Subject: Docket Nos. 50-361 and 50-362
Response to Request for Additional Information Regarding
Generic Letter 95-07, Pressure Locking and Thermal Binding
of Safety-Related Power-Operated Gate Valves
San Onofre Nuclear Generating Station Units 2 and 3 (TAC Nos.
M93515 and M93516)

Reference: Letter dated June 15, 1999 from L. Raghavan (NRC) to Harold B. Ray (SCE), Subject: San Onofre Nuclear Generating Station (SONGS), Units 2 and 3 - Request for Additional Information - Generic Letter 95-07, Pressure Locking and Thermal Binding of Safety-Related Power-Operated Gate Valves (TAC Nos. M93515 and M93516)

**RESPONSE TO NRC GENERIC LETTER 95-07
NRC REQUEST FOR ADDITIONAL INFORMATION**

Figure 1 P&ID Showing SDC WKM Valves

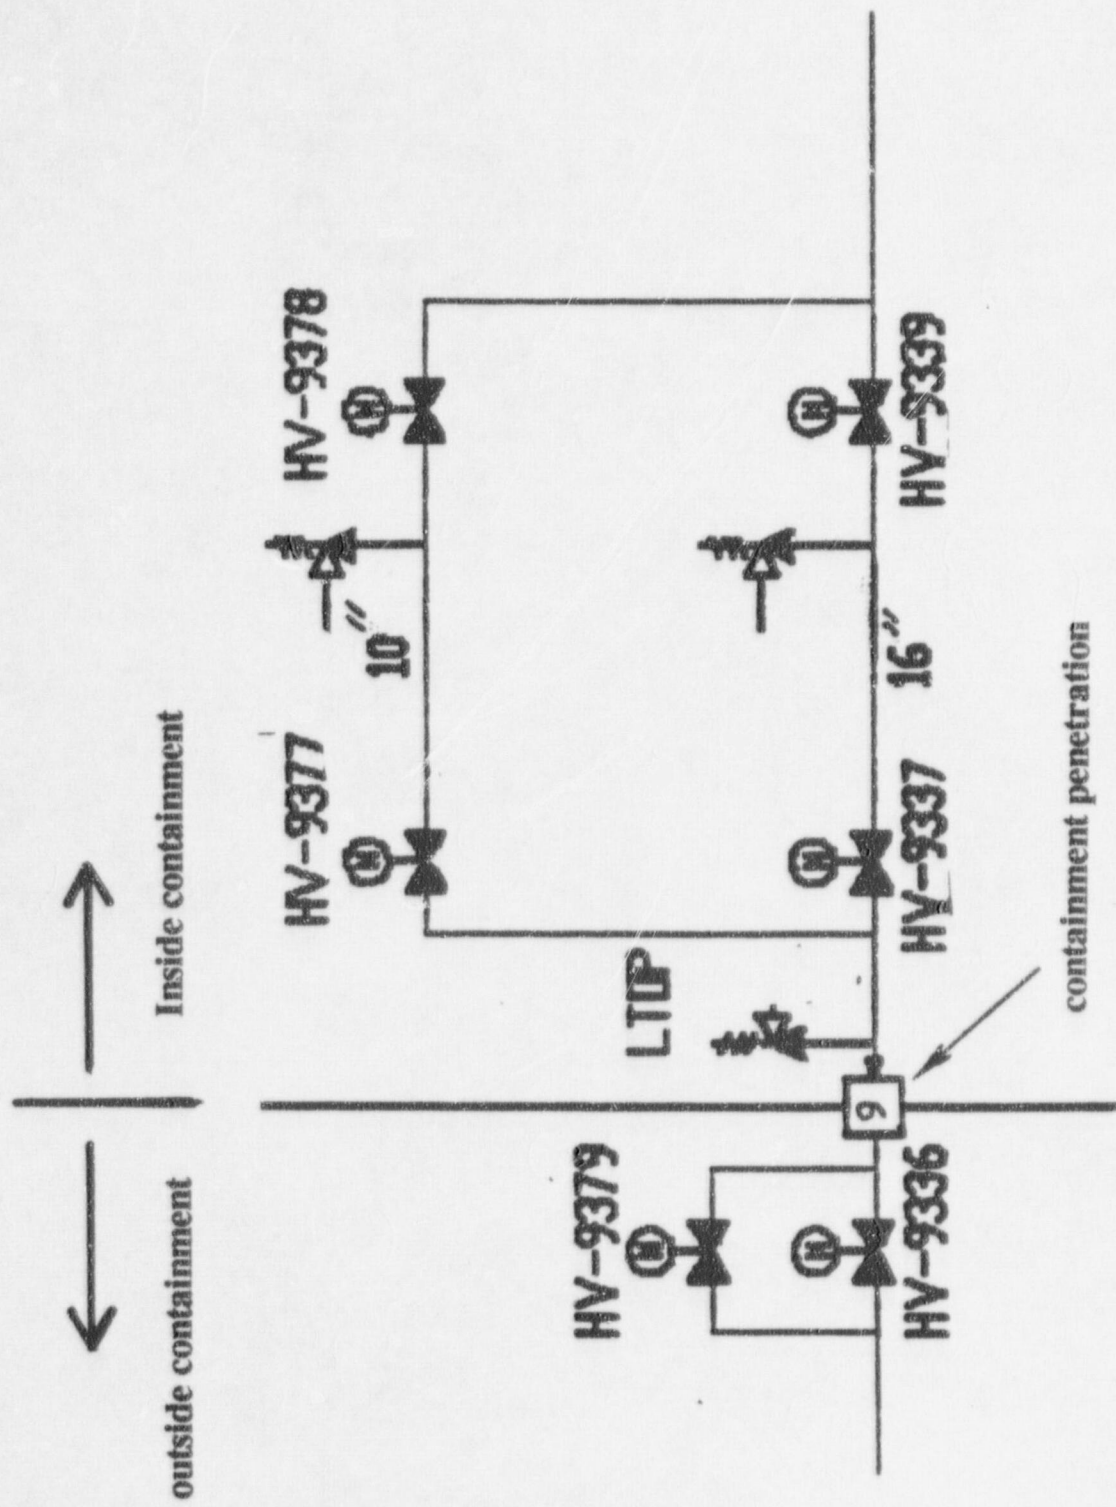
Your submittal dated February 13, 1996, states that you credit the internal relief valve installed in the disk of WKM valves to prevent bonnet pressure from exceeding the upstream pressure by 300 psi. The NRC staff considers that failure of the internal relief valve to relieve pressure in the bonnet could prevent a valve from opening during pressure locking conditions. Please:

- a. discuss if you periodically test the internal relief valve, and if not tested, explain why testing is not required;
- b. explain why the internal relief valve feature is not required to be included in your inservice testing program; and
- c. explain why WKM valves are equipped with an internal relief valve. Normally, valves are not equipped with an internal relief valve.

Several gate valves manufactured by WKM were identified in Southern California Edison's (SCE) submittal of February 13, 1996 (Reference 1) as valves with potential functional impact due to pressure locking. Since submittal of the SCE response, the screening criteria calculation (A-95-NM-MOV-PL/TB-002, Rev. 2) has been revised to remove the Emergency Core Cooling system (ECCS) Miniflow Valves 2(3)HV9306, 9307, 9347, and 9348 from the pressure locking/thermal binding (PL/TB) scope since further review of the system functional requirements indicated that these valves have a closing safety function only and are therefore exempt from the scope of GL 95-07. The remaining WKM valves which are currently considered as susceptible to pressure locking are the shutdown cooling (SDC) valves identified in Table 1. Figure 1 is a Piping and Instrumentation Diagram (P&ID) representing part of the SDC system. The figure shows schematically the location of the SDC valves inside and outside containment.

Valves HV9378 and HV9339 (shown in Figure 1) provide the first isolation boundary between the reactor coolant system (RCS) and the SDC system. The potential for pressure locking occurs as a result of leakage past the upstream seat which pressurizes the bonnet to the RCS pressure of approximately 2,250 psia. The SDC system is initiated after the upstream RCS pressure is reduced to below 400 psia. It is postulated that the RCS fluid would remain trapped in the bonnets of these valves. Without pressure relieving, the high pressure of the water trapped in the bonnet cavity causes the segment and the gate to press tightly against the seats. The pressure locking scenario for valves HV9377 and HV9337 is similar to that of HV9378 and HV9339 since SONGS assumes (for the purpose of the pressure locking analysis) that the primary isolation valves (HV9378 and HV9339) leak by and subject the secondary isolation valves (HV9377 and HV9337) to RCS pressure as well. Since all four inside containment SDC valves were identified as susceptible to conventional pressure locking, no further analysis was performed to determine if these valves could also be subjected to thermally induced pressure locking.

The SDC valves outside containment (HV9379 and HV9336) were conservatively included in the scope of GL 95-07 based on function only. These valves are normally closed and are required to open to perform their safety function. A detailed system analysis to determine if these valves could actually experience a conventional or thermally induced pressure locking condition was not performed. Upon further review it is considered unlikely that these valves would actually be subjected to a pressure locking transient at the time they are required to open, however, SONGS has chosen to conservatively assume that pressure locking is feasible for these valves.
